UNITED STATES PATENT AND TRADEMARK OFFICE

APPLICATION NO.	FILING DATE	FIRST NAMED INVENTOR	ATTORNEY DOCKET NO.	CONFIRMATION NO.
09/822,175	04/02/2001	Kazuhiko Yanagawa	HITA.0045	7332

Office Action Summary

DETAILED ACTION

FIG.12A**FIG.12B**

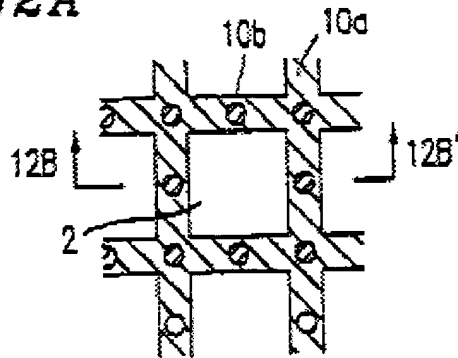
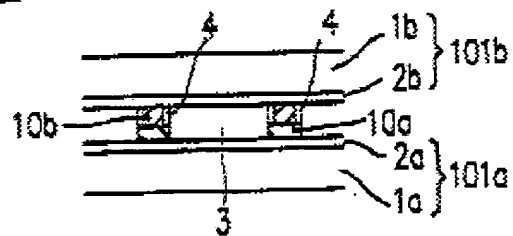
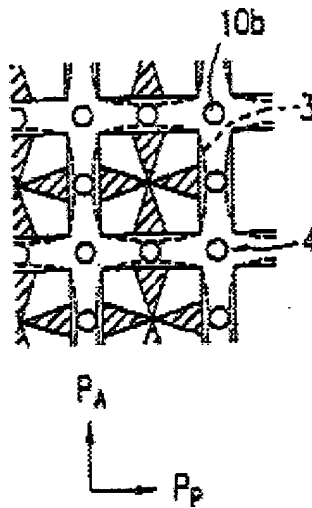
As to claim 35, Onishi discloses in Figures 12A-12C a liquid crystal display device of Example 1 (col. 17, line 60 through col. 33, line 34; especially col. 31, line 1 through col. 33, line 34) comprising a pair of substrates, 1a and 1b, as disposed to spatially oppose each other with a layer of liquid crystal material interposed therebetween and a seal material, 4, used for adhesion of one of the substrates to a remaining substrate, said seal material also having a function of encapsulating the liquid crystal material, wherein

a plurality of photolithographically formed (col. 31, lines 25-32) projection bodies, 10b, are precisely dispersed on one of said substrates in a predetermined shape thereof

at a desired location thereon, and then said seal material is formed on said one of said substrates to bury said projection bodies therewithin (as illustrated in Figure 12B) (see also masks illustrated in Figures 11 and 13).

As to claim 36, Onishi discloses in Figures 12A-12C a liquid crystal display device of Example 1 (col. through col. 33, line 34) the liquid crystal display device as recited in claim 36, wherein said plurality projection bodies are parallel-disposed (columns are parallel to each other and rows are parallel to each other, per Figure 12C).

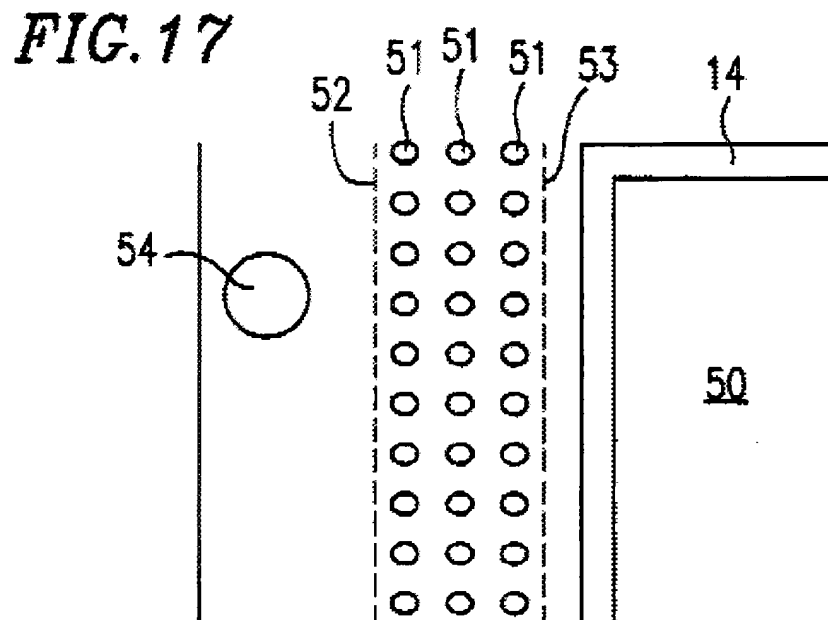
Nakahara teaches in Figure 17 a device comprising a plurality of parallel-disposed sealant particles, 51, (Applicant's projection bodies) about the perimeter of the display area to minimize stress distortion and waviness of the glass plates (col. 12, line 66 through col. 13, line 8).

Nakahara is evidence that ordinary workers in the art of liquid crystals would find the reason, suggestion, or motivation to add a plurality of parallel-disposed sealant particles (Applicant's projection bodies) to minimize stress distortion and waviness of the glass plates

Therefore, it would have been obvious to one having ordinary skill in the art of liquid crystals at the time the invention was made to modify the LCD of Onishi which has photolithographically formed projection bodies buried in seal material, with the plurality of parallel-disposed sealant particles (Applicant's projection bodies) about the perimeter of the display area of Nakahara to minimize stress distortion and waviness of the glass plates.
